**Sunrise Coalition Comments on
Stormwater Issues at Proposed Bradley Ridge Subdivision**

Submitted to Chapel Hill Town Council
January 2008

Summary of Sunrise Coalition Comments on Stormwater Issues at Proposed Bradley Ridge Subdivision

FIGURE 1

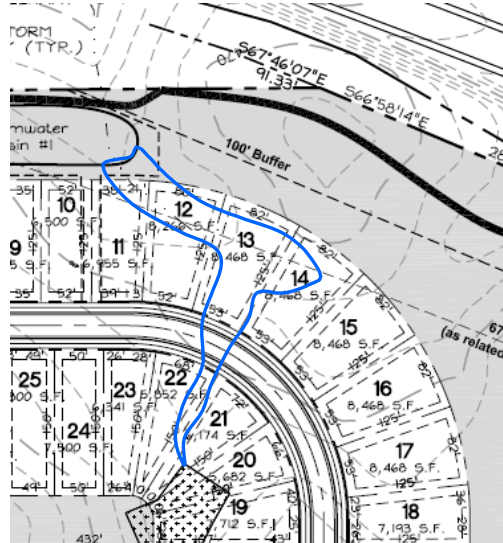
The Applicants’ Preliminary Plat and Stormwater Impact Statement do NOT indicate that measures will be taken to minimize impacts to the hydrologic functions of the small stream and associated wetlands in the Basin 1 drainage area. The approximate boundaries of this wet zone are delineated in Figure 1. As noted above, this wet zone includes a stream channel that was classified initially by Town Engineers as an intermittent stream and subsequently reclassified.

As currently proposed, the Bradley Ridge development will disrupt the hydrologic functions of the wet zone shown in Figure 1 and the associated drainage line that extends from the mapped wetland near the former Potted Plant to Basin 1. This area currently retains much of the stormwater, sediment and nutrients that pass through it. The area is effectively functioning now as a stormwater control. Seasonal perched water tables develop in this area with as much as 6” of standing water over extensive areas during wet periods. Seasonally wet soils with forest cover in the area are ideal for reducing stormwater quantity and improving quality.

Seasonally saturated area: Intermittent Drainage

CH stormwater engineers cited the **significance of the area** and recommended that **disturbance be avoided or minimized**.

Request the determination be revisited to confirm adherence to LUMO –

- important precedent for Town
- Clearly state reasons for determination with reference to LUMO guidelines

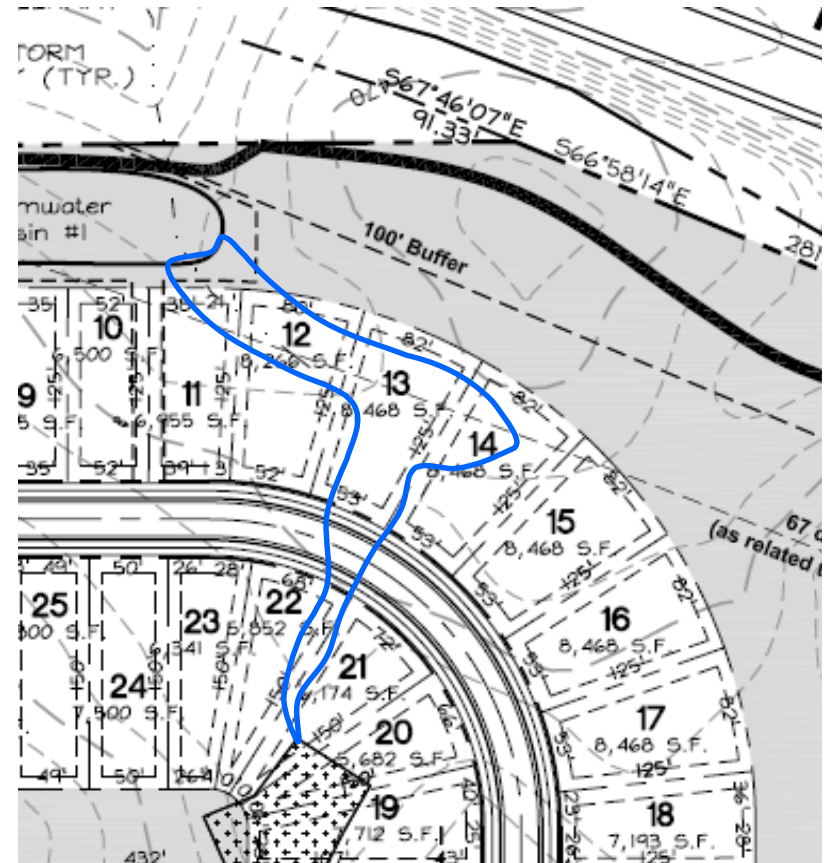
- Eastern portion of HHOC property that would drain into “Basin 1.”
- Basin 1 drainage area includes linear feature classified by Town Engineers as intermittent stream in 2003.
- At request of HHOC, intermittent stream reclassified in 2004. Town Engineers note that “boggy area” has “important hydrologic functions” and recommended that impacts be “avoided or minimized.”

Seasonally saturated area: Intermittent Drainage

CH stormwater engineers cited the **significance of the area** and recommended that **disturbance be avoided or minimized**.

Request the determination be revisited to confirm adherence to LUMO –

- important precedent for Town
- Clearly state reasons for determination with reference to LUMO guidelines
